FAIRFAX COUNTY

STAFF REPORT ADDENDUM II

APPLICATION RZ/FDP 2000-MV-019

APPLICANT: Washington Homes, Inc.

ALTERNATIVE PLAN FOR
PLASKETT LANE ENTRANCE AREA
SCALE: 1" = 100'

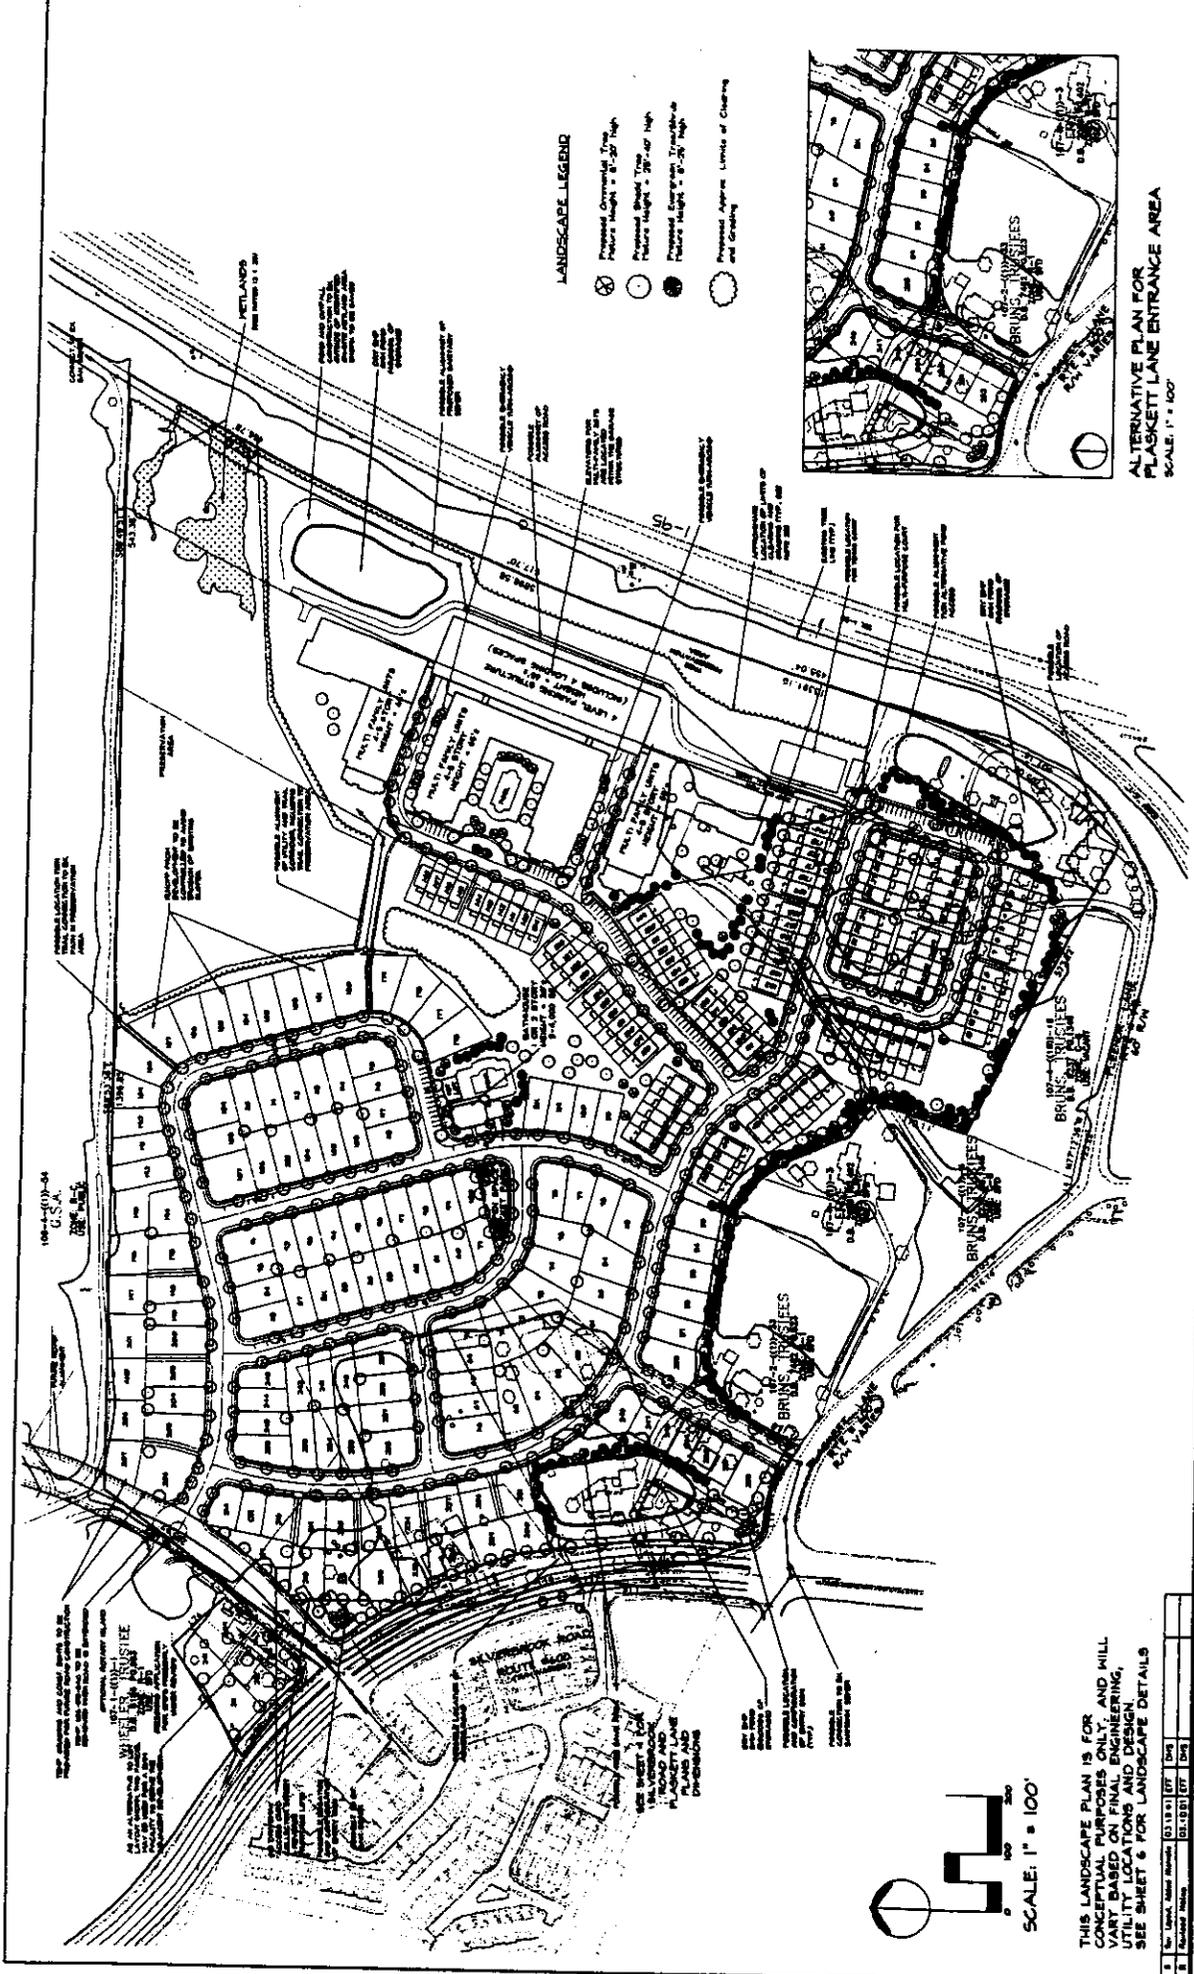
While the general layout of the revised CDP/FDP is very similar to the layout of the previous submissions, some of the details on the plan have been revised to reflect the change in unit mix, new design concepts for a portion of the single family detached units, a new location for the access to Plaskett Lane, among other things. With regard to the change in access to Plaskett Lane, the alternative location for the roadway connection to Plaskett Lane has been deleted and the connection near the intersection with Silverbrook Road, shown previously as temporary, has been designated as the location for a permanent connection to Plaskett Lane. In addition, a possible alternative layout for the connection to Plaskett Lane, which shifts the road approximately twenty-five (25) feet further from the intersection is included as an inset on Sheet 2.
